Access Compliance Report

Public Rights-of-Way

(Curb Ramps)

Intersection ID: 17062	Main Street: IDLEWILD_RD	Cross Street: MONROE_RD	Location: SE
ADA ID: C39B56454FEF	Ramp Type: BlendTrans1	Initial Pass/Fail: Fail	Overall Compliance: No
Severity Score: 12.5			
Codes/Mitigation Info/Possible Solution		Field Measurements/Component Compliance

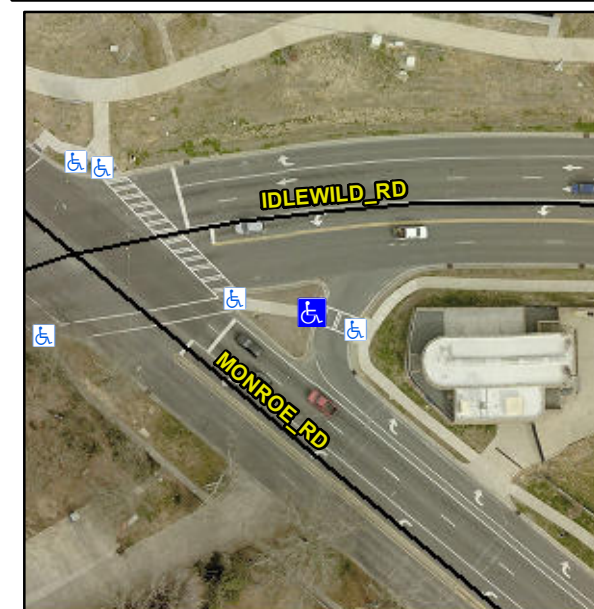
Not Found, R304.5.3

Compliance	Description	Data	Compliance	Description	Data
N/A	Ramp Length (in)	68.0	Yes	BlendTrans Slope (%)	3.8
Yes	Ramp Width (in)	48.0	No	BlendTrans XSlope (%)	5.3
N/A	Flare Type LT	N/A	N/A	Flare Type RT	N/A
N/A	Flare Slope LT (%)	N/A	N/A	Flare Slope RT (%)	N/A
N/A	Flare Traversable LT?	N/A	N/A	Flare Traversable RT?	N/A
N/A	Landing Length (in)	N/A	N/A	DWS Provided?	N/A
N/A	Landing Width (in)	N/A	N/A	DWS Contrast?	N/A
N/A	Landing Slope (%)	N/A	N/A	DWS Length (in)	N/A
N/A	Landing X Slope (%)	N/A	N/A	DWS Full Width?	N/A
N/A	Landing Curb? (Y/N)	N/A	N/A	DWS Offset (in)	N/A
N/A	Shared Landing?	N/A			
N/A	Gutter Ponding?	N/A	N/A	Gutter Slope (%)	N/A
N/A	Gutter Lip Ht (in)	N/A	N/A	Gutter X Slope (%)	N/A
N/A	Painted X Walk1?	Yes	N/A	Painted X Walk2?	N/A
	X Walk 1 Direction	To SE		X Walk 2 Direction	N/A
	X Walk 1 Width (in)	112.0		X Walk 2 Width (in)	N/A
	X Walk 1 Slope (%)	0.4		X Walk 2 Slope (%)	N/A
	X Walk 1 X Slope (%)	4.7		X Walk 2 X Slope (%)	N/A

N/A	Ramp inside XWalk1?	Yes	N/A	Ramp inside XWalk2?	N/A
	Road Slope (%)	4.7		Clear Space?	N/A
	Road X Slope (%)	0.4	N/A	Clear Space to XWalk (in)	N/A
N/A	Any Obstructions?	N/A	N/A	Storm Grate/Utility Hazard?	N/A
	Obstruction Type			Storm Grate/Utility Type	
		N/A			N/A
			Yes	Surface Condition? (G/P)	Good
			No	Curb Slope (%)	6.1

Remove & Replace Curb Ramp With Two New Directional Ramps or Equivalent.
